PLANNING CLEARANCE
 (Single Family Residential and Accessory Structures)
Community Development Department

Building Address 2928 Brook View Lane No. of Existing Bldgs 0 No. Proposed 1
 Parcel No. 2943-292-39-014 Sq. Ft. of Existing Bldgs 0 Sq. Ft. Proposed 2774
 Subdivision Riverview Estates Sq. Ft. of Lot / Parcel 8096.5
 Filing 1 Block 4 Lot 14 Sq. Ft. Coverage of Lot by Structures & Impervious Surface (Total Existing & Proposed) 2810
 Height of Proposed Structure 17' 11"

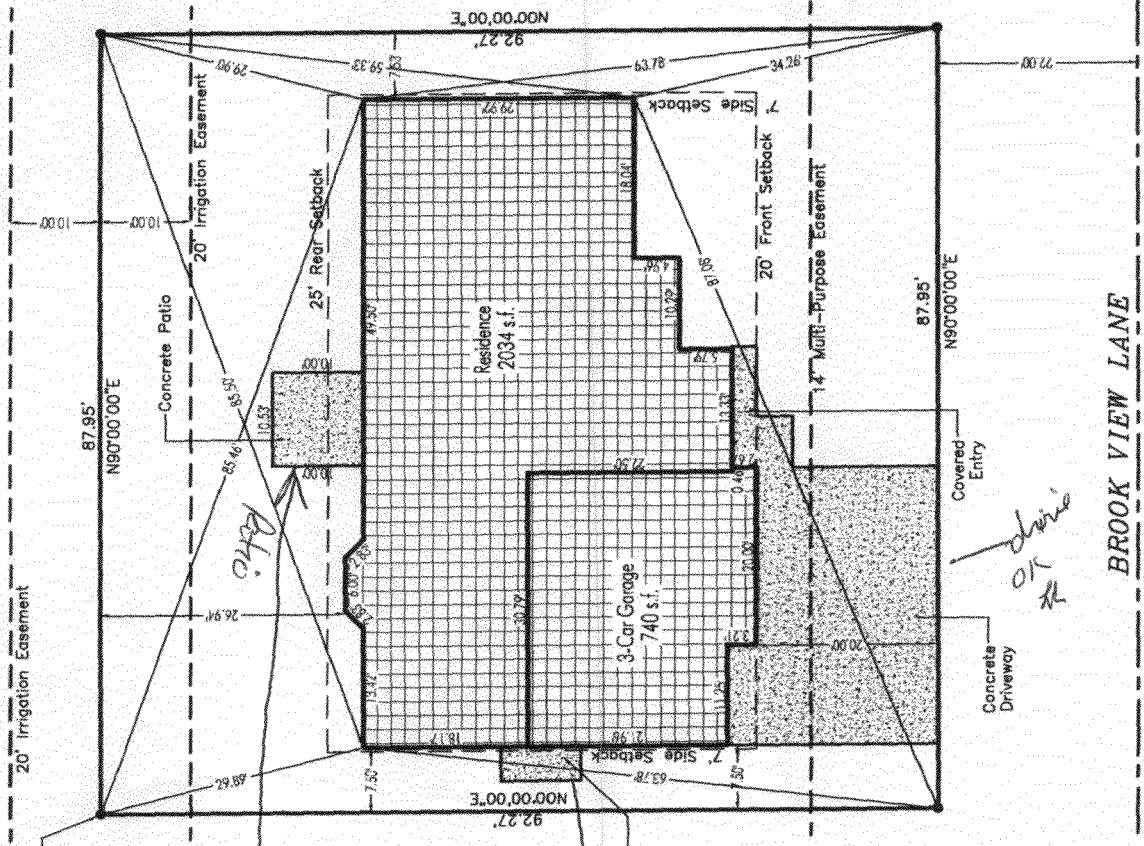
See permit
patio can only encroach into setback 6'
**unless flush slab*

AC pad can only encroach 3' into setback -

drive OK
